WEST SENECA
PLANNING BOARD

Planning Board Proceedings
DRAFT Minutes #2026-10
October 8, 2026

Re: Site Plan Review
Multi-Family Apartment Building
2806 Seneca Street

The applicant is pleased to submit the materials included herewith in response to the engineering comment letter dated September 21, 2026. The comments of the review letter are replicated below with our responses in bold for ease of review. Included herewith are the following materials:

SITE PLAN

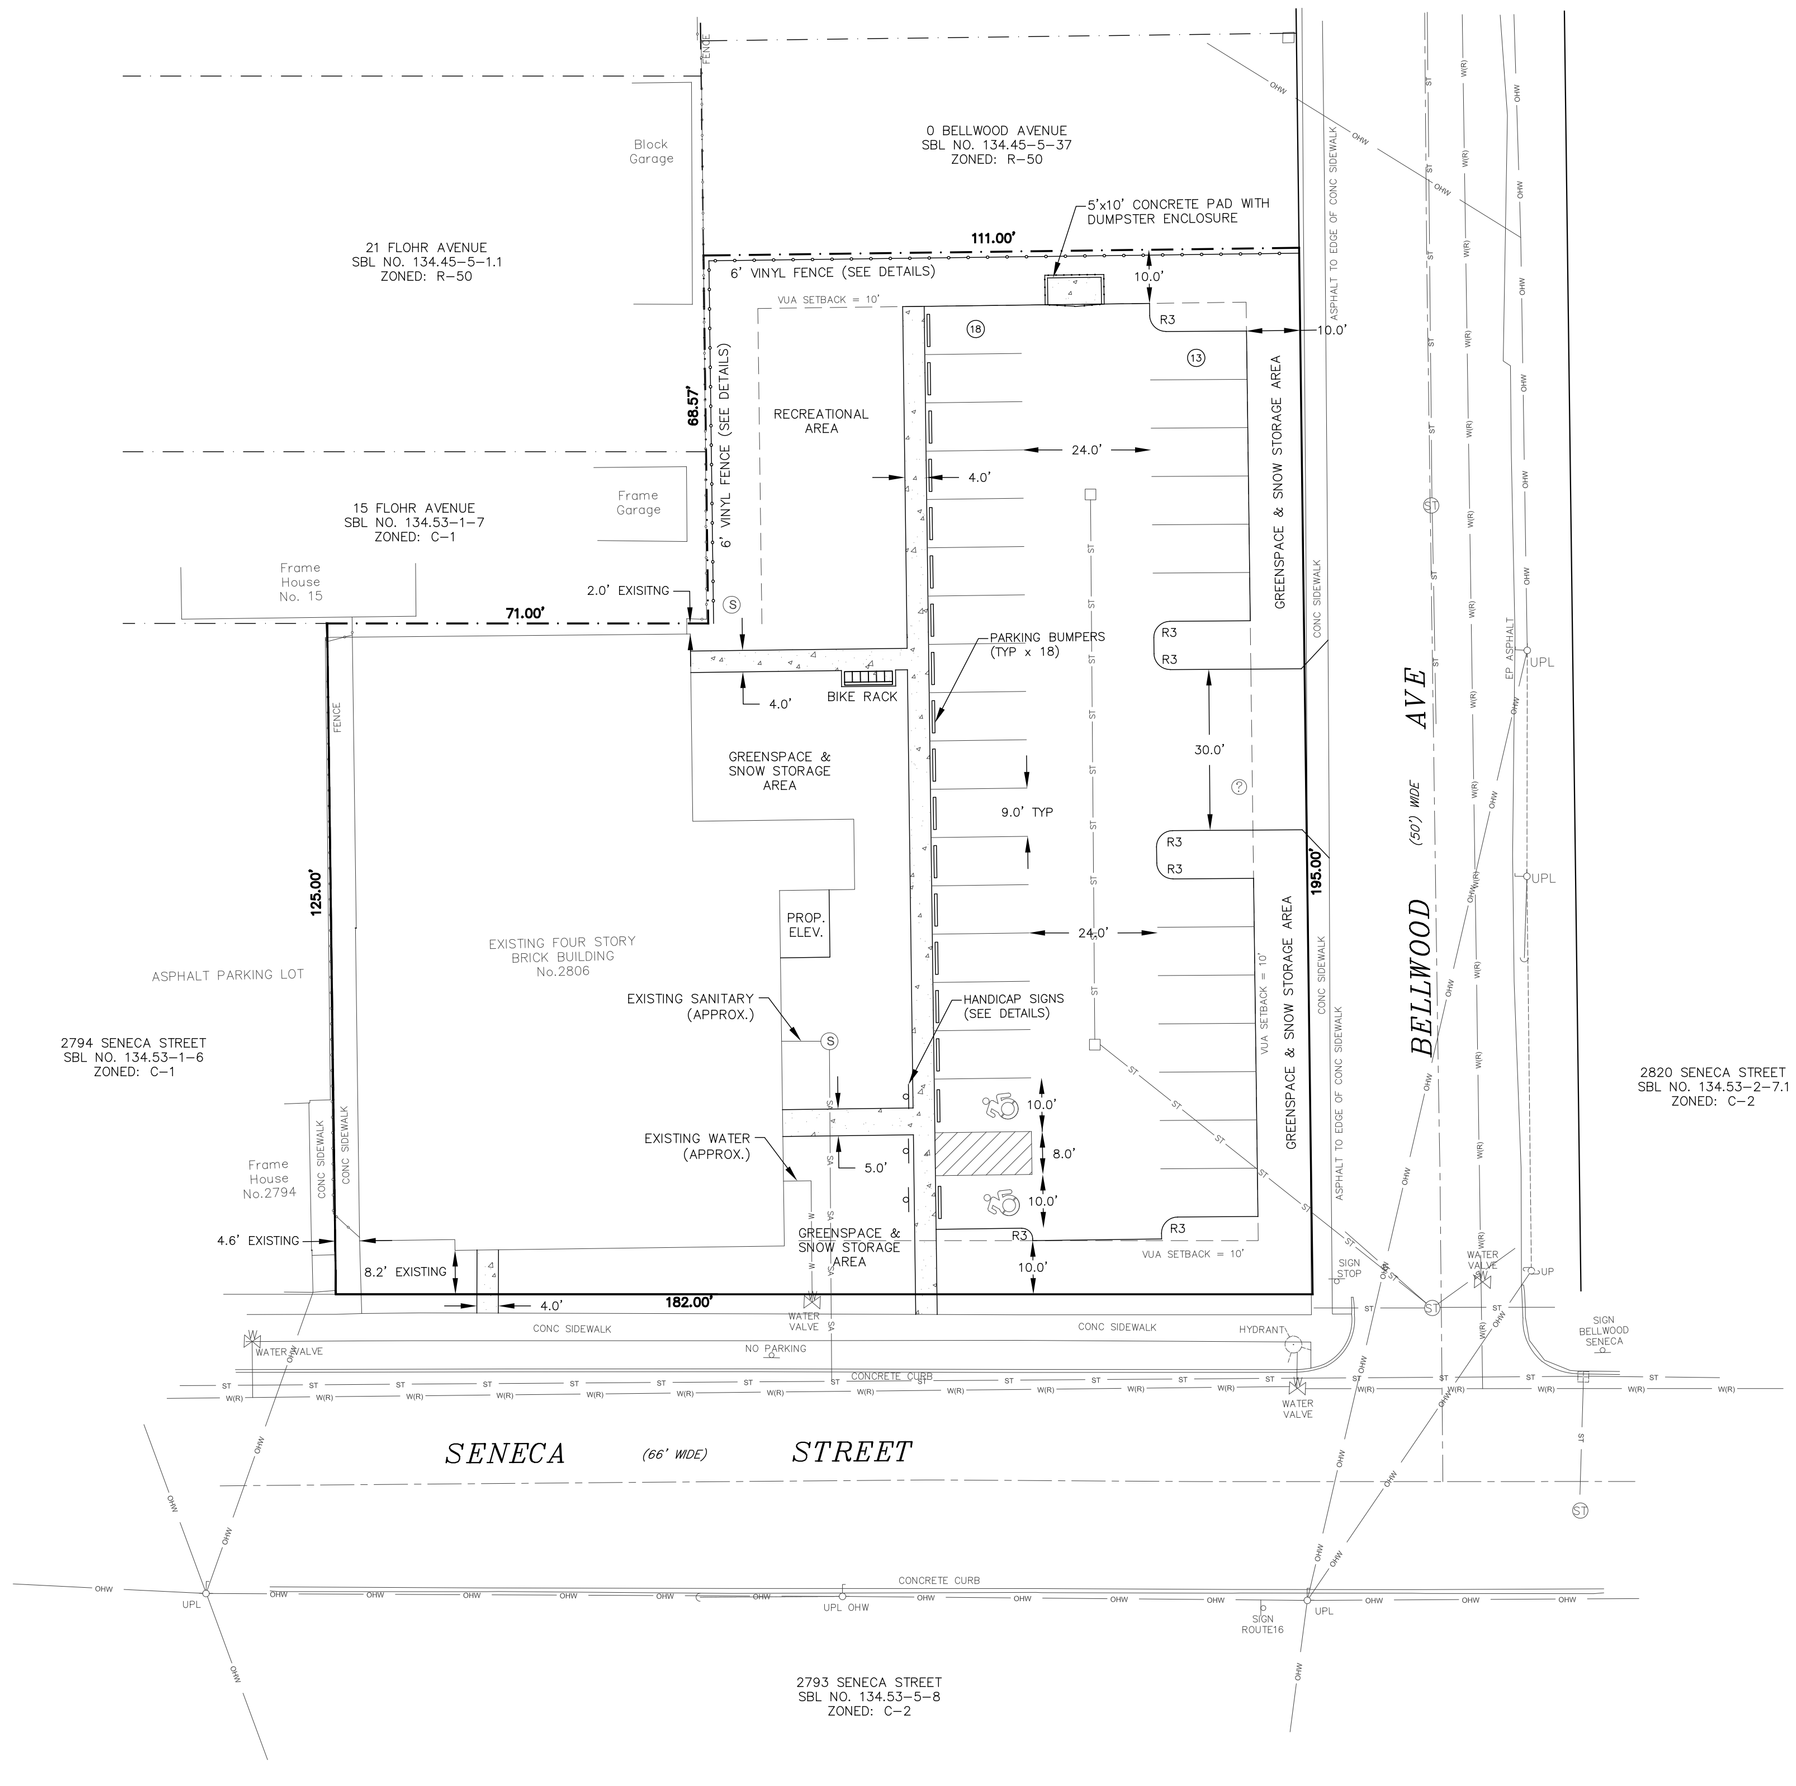
SP-1 – SITE PLAN:
Comment 4: Are sidewalk areas adjacent to the parking lot proposed to be installed flush to adjacent pavement, or will curbing be installed? If curing is to be provided, please provide details on the curbing and provide ADA accessible curb ramps. If no curing is proposed, we recommend concrete bumpers be included to separate parking spaces from pedestrian pathways.
Response: No curbing is proposed. As such, and to provide safety for pedestrian walkways, parking bumpers have been specified.

Comment 5: Are any dumpsters proposed to be utilized on site? If so please mark their location.
Response: The concrete pad and dumpster enclosure has been added to the plans at the north end of the drive lane. A corresponding detail has also been included on the detail sheet (DT-1).
